## **Committee of Experts on the Transport of Dangerous Goods and on the Globally Harmonized System of Classification and Labelling of Chemicals**

**Recommendations made by the Sub-Committee on its forty-third, forty-fourth  
and forty-fifth sessions and pending issues: electric storage systems**

### **Report on the third meeting of the informal working group on testing large lithium batteries. Addendum to INF 11, Figure 1 and Figure 2.**

**Transmitted by the expert from France (in his capacity as Chairman of  
the informal working group), PRBA, RECHARGE and COSTHA**

*FIGURE 1. Relation between the Peak Acceleration and the Mass for small batteries (below 12.0 kg).*

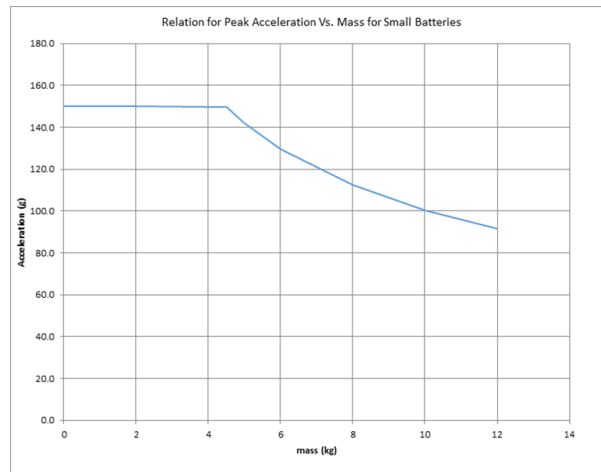
Each battery shall be subjected to a half-sine shock of peak acceleration depending on the mass of the battery. The pulse duration shall be 6 milliseconds for small batteries and 11 milliseconds for large batteries. The formulas below are provided to calculate the appropriate minimum peak accelerations.

Battery	Minimum peak acceleration	Pulse duration
Small batteries	150 $g_n$ or result of formula $Acceleration (g_n) = \sqrt{\left(\frac{100\ 850}{mass}\right)}$ whichever is smaller	6 milliseconds
Large batteries	50 $g_n$ or result of formula $Acceleration (g_n) = \sqrt{\left(\frac{30\ 000}{mass}\right)}$ whichever is smaller	11 milliseconds

The relationship between minimum peak acceleration and mass is illustrated in Figure 1 for small batteries and Figure 2 for large batteries.

*FIGURE 2. Relation between the Peak Acceleration and the Mass for large batteries (above 12.0 kg).*

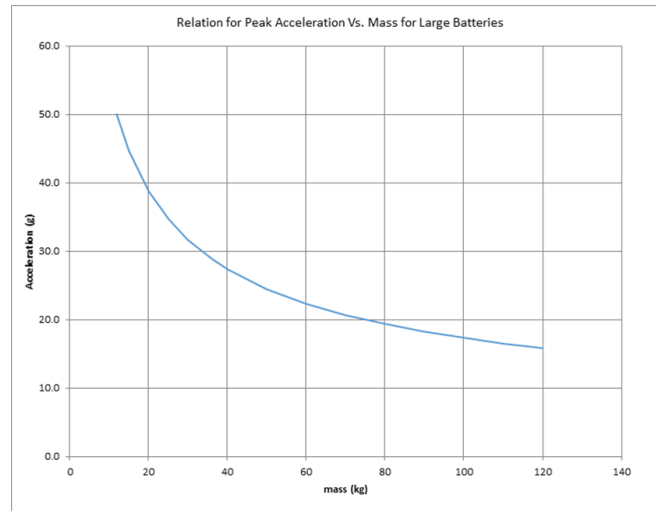
~~However, large batteries shall be subjected to a half-sine shock of peak acceleration depending on the mass of the battery. The pulse duration shall be 11 milliseconds. The formula below is provided to calculate the appropriate minimum peak acceleration.~~

$$Acceleration (g_n) = \sqrt{\left(\frac{30\ 000}{mass}\right)}$$

~~The relationship between minimum peak acceleration and mass is illustrated in the Figure 2.~~

*NB. The final numbering of the Figures will be decided according to the Committee's decision on Option 1 and Option 2.*
